# City of Boulder, Colorado

## Review of Updated Model for New Electric Utility

*October 15, 2013*

**SUPPLEMENTAL REVIEW OF UPDATED MODEL (JULY 2013)  
FOR NEW ELECTRIC UTILITY**

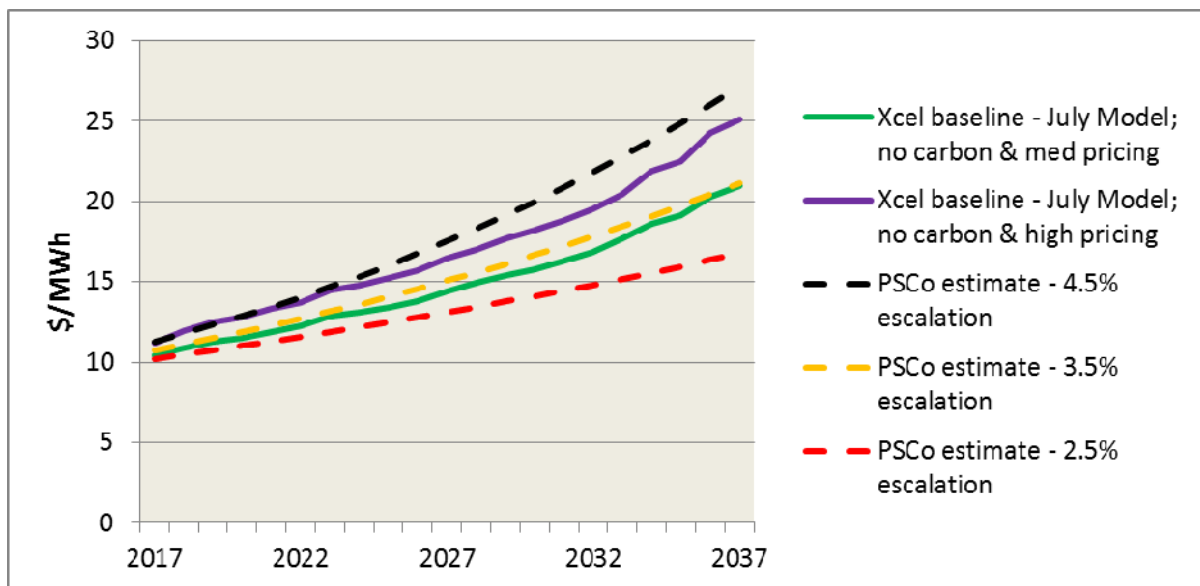
As part of its reasonableness test, PowerServices then compared Boulder’s Xcel baseline to the PSCo estimate. Both the median and high priced generation scenarios were tested against PSCo rates using a low, average and high escalation rate. Carbon costs were excluded due to the uncertainty of applying this cost to a PSCo portfolio.

The results show that Boulder’s estimate of Xcel rates with median generation pricing is at or below PSCo’s forecasted rates that escalate at the historical average. It is reasonable to assume that Boulder’s estimate may be slightly lower than the PSCo system forecast due to the high load factor in the Boulder region. The Xcel baseline with high generation costs initially tracks a PSCo forecast growing at 4.5%, but then follows a more moderate trajectory. This indicates that Boulder’s forecast did not incorporate overly aggressive escalation in Xcel rates. PowerServices finds the model refinements and resulting impacts to the Xcel baseline to be reasonable and conservative.
